Port of Gaspé – Sandy Beach Sediment Remediation Project

Environmental Impact Assessment filed with the with the Quebec Ministry of Sustainable Development, Environment, Wildlife and Parks (MDDEFP)

Addendum

September 2012
O/Ref.: 045-P001130-0162-EI-0200-00

Appendix 5 Process Diagrams

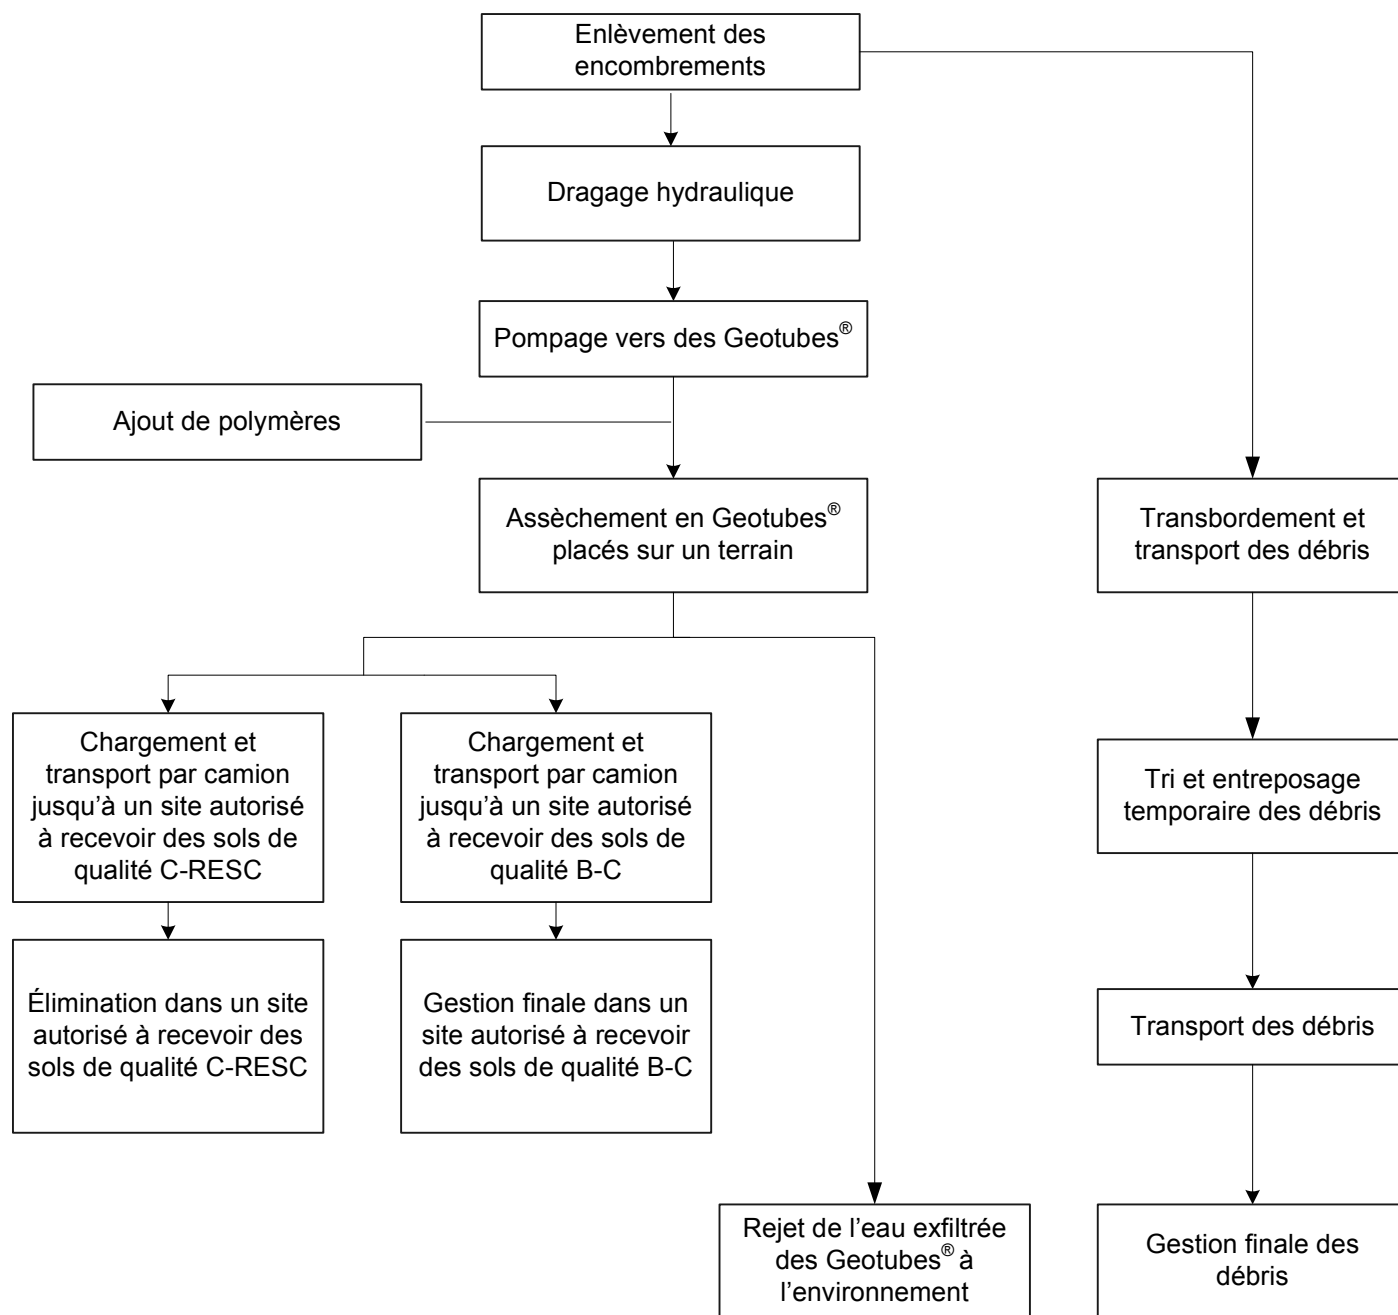
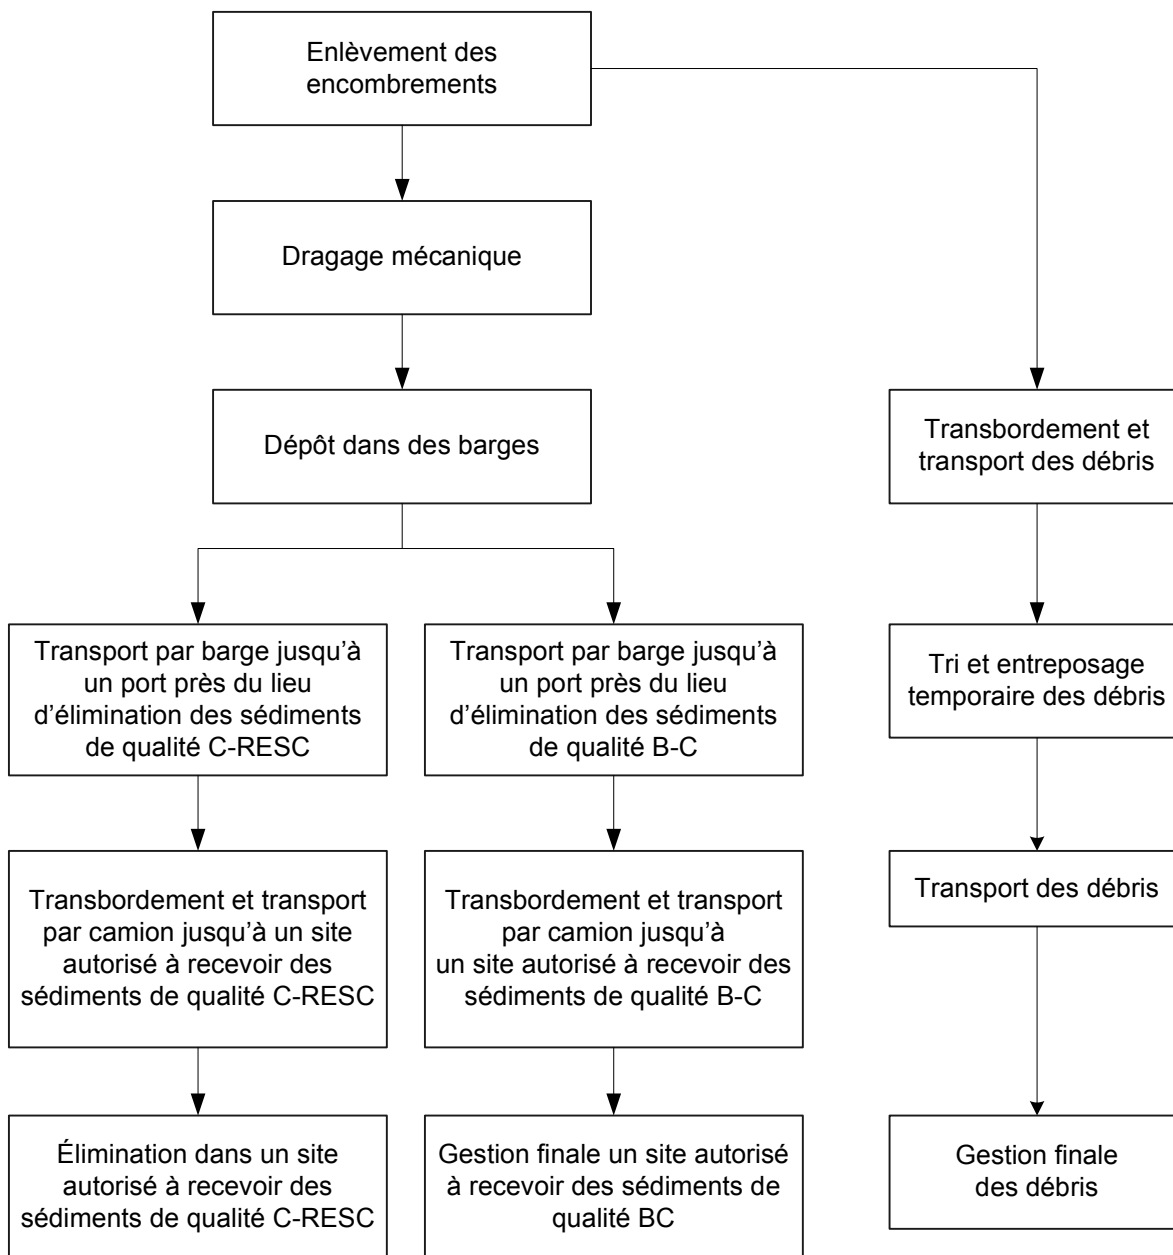
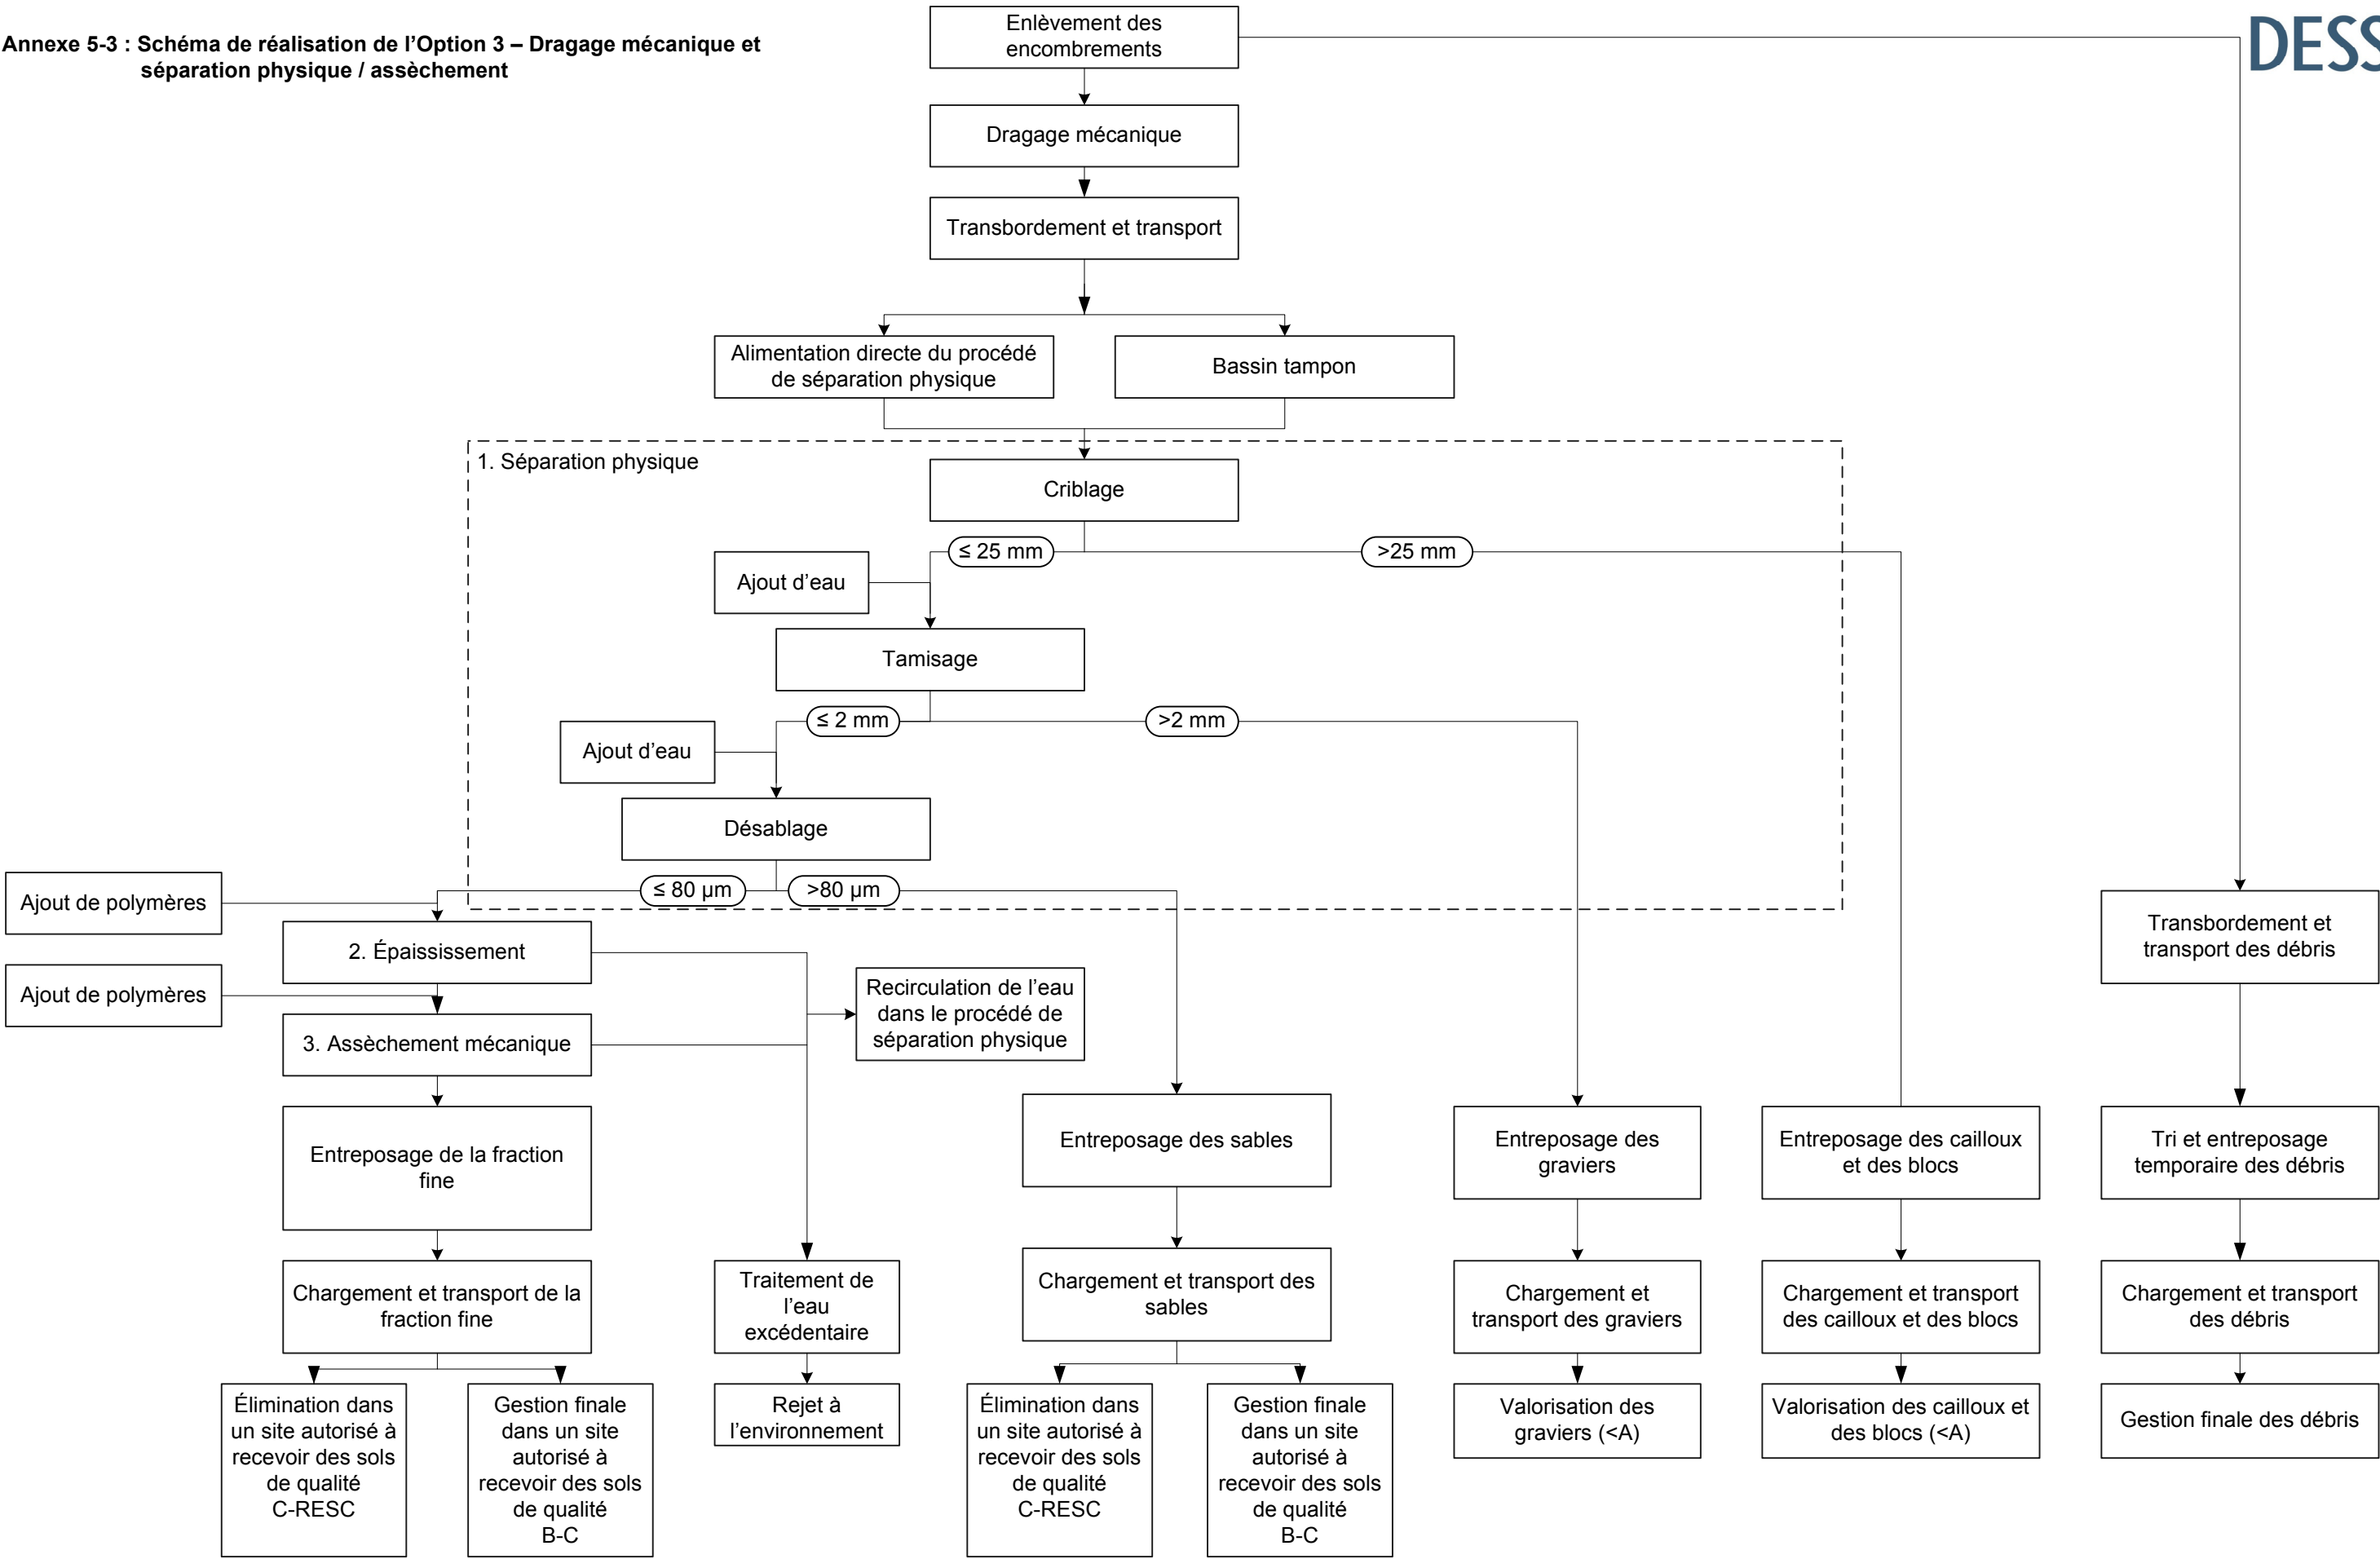
QC-11: The project proponent must assess the use of Geotubes® as an option for the bay of Gaspé project. Geotubes® are used as a complement to hydraulic dredging and will separate the water and sediment. They are an interesting alternative to the dewatering basin. As mentioned at the meeting on June 18, 2012, the MDDEP is prepared to provide references on the application of this proven technology.

Figure B-17 révisée

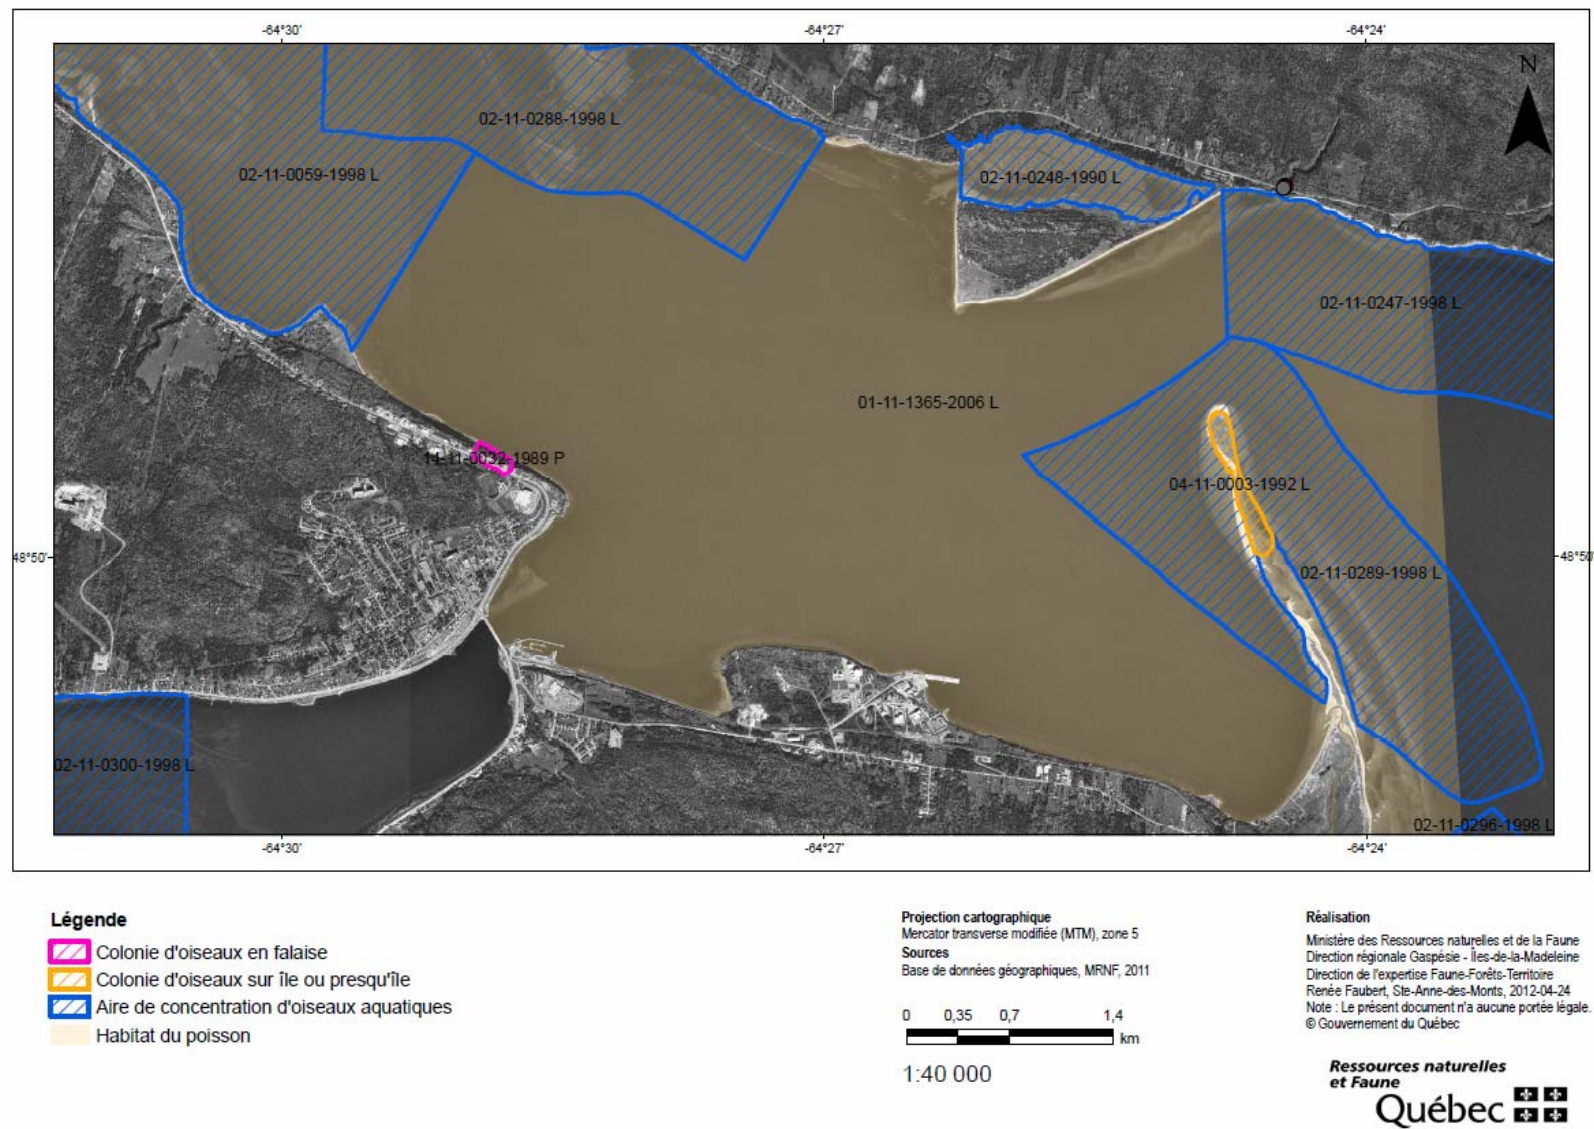
QC-31: The project includes several components, but only the dredging of the contaminated sediment takes place in a wildlife habitat, the Gulf of St. Lawrence (bay of Gaspé) fish habitat. This habitat is now legally recognized under the *Loi sur la conservation et la mise en valeur de la faune*. Figure B-17 on page C-9 does not present the bay of Gaspé legal fish habitat and must be replaced by the figure appended to Appendix 1.

In light of this, the revised Figure B-17 presented in Appendix 7 replaces Figure B-17 appearing on page C-9 of the environmental impact assessment. The latter presents the location of the fish habitat in the study area.
